PARISH OF ASCENSION
OFFICE OF PLANNING AND DEVELOPMENT
PLANNING DEPARTMENT

Planning Commission

October 12, 2016 - 6:00 PM
Courthouse East, 2nd Floor, Council Meeting Room
Gonzales, Louisiana

AGENDA

FINAL PLAN

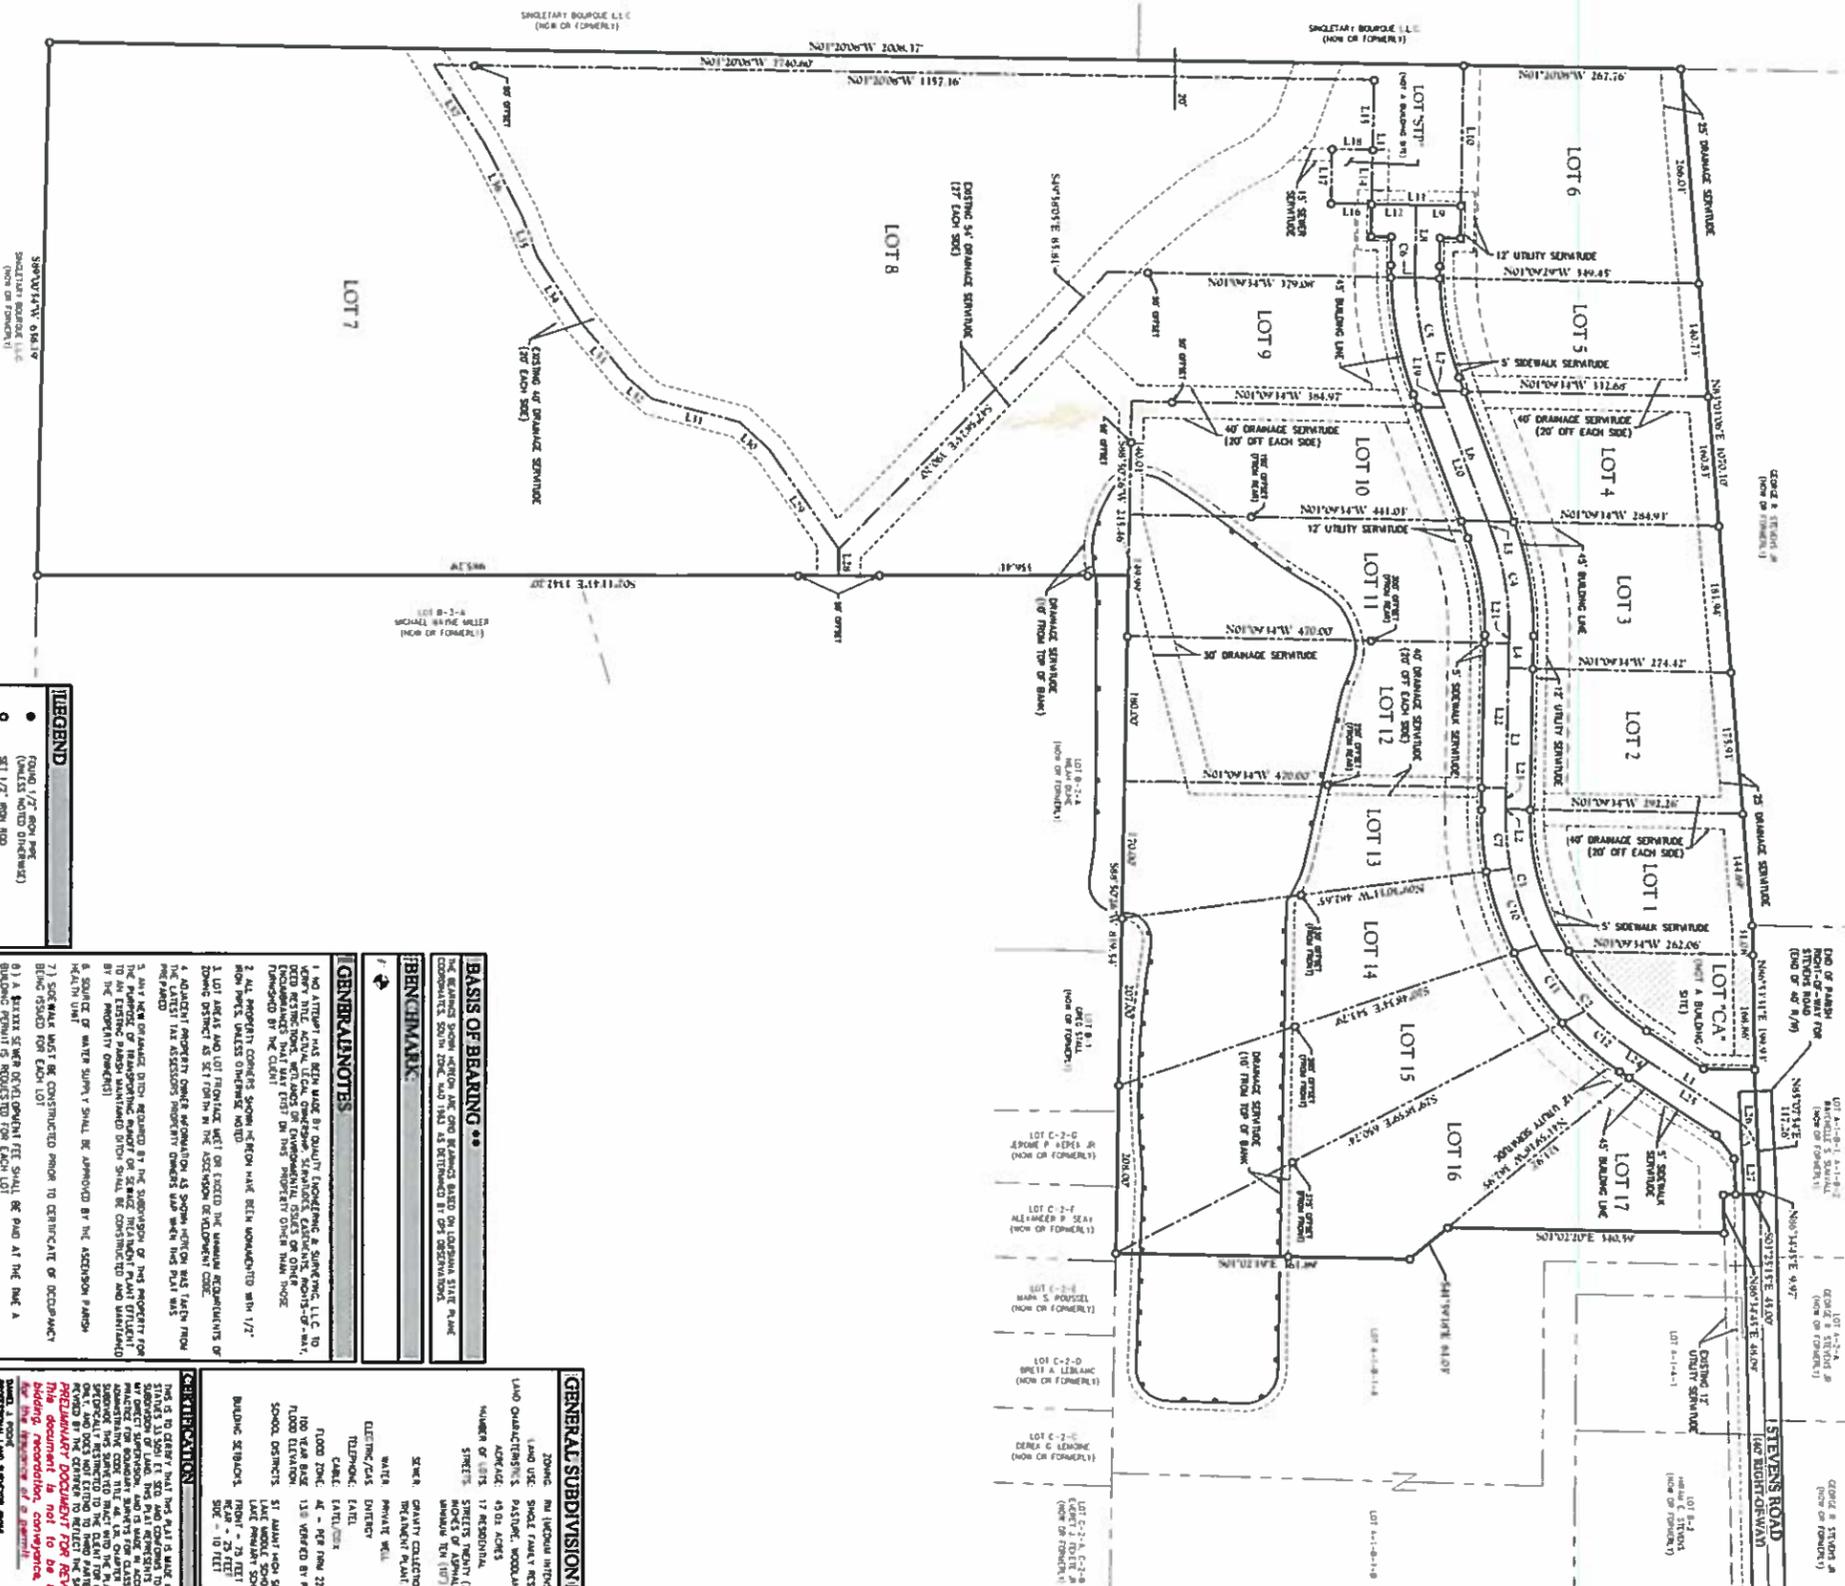
1. Provide the following closeout items if not already provided.
 - a. Provide as-builts that satisfy section 17-4010C of the UDC.
 - b. Provide engineering and testing certifications.
 - c. Provide all testing reports if not already submitted.

1. Make sure the final plat has the following note regarding traffic impact fee. "All single family residences are required to pay a transportation impact fee in accordance with the established Ascension Parish Ordinances."
2. Add note to plat stating the tree planting requirement for each future lot owner.

1. Regrade fill slope above pipe B3 to B2.
2. Provide rip rap that is a 30# blend at the end of Ditch 1 as shown on sheet 13 of the approved construction plans. Make sure rip rap is installed so that it is below invert of ditch. Make sure geotextile fabric is used as noted in the approved construction plans.
3. Provide rip rap that is a 30# blend at the end of pond outfall pipes as shown on sheet 16 of the approved construction plans. Make sure rip rap is installed so that it is below invert of ditch. Make sure geotextile fabric is used as noted in the approved construction plans.

1. Provide DHH approval for pump station and discharge location.
2. East Baton Rouge manhole lids are used. Replace manhole lids.
3. Complete electric tie-in to pump station and provide a start-up test for inspector.

1. Install handicap ramps and the culverts that go under the ramps.
2. Install the sidewalk that is noted as, "By Developer".
3. Per section 17-4020, the park must have at least 6 Class A trees and 12 ornamental trees in the park. Please plant trees..

1. Since Maple Grove Drive will be a private access servitude, add private maintenance sign at the end of the existing 40 ft public Stevens Road right of way.
2. Move the keep-right sign that is near station 10+00 and move to the nose of the island at station 10+70.
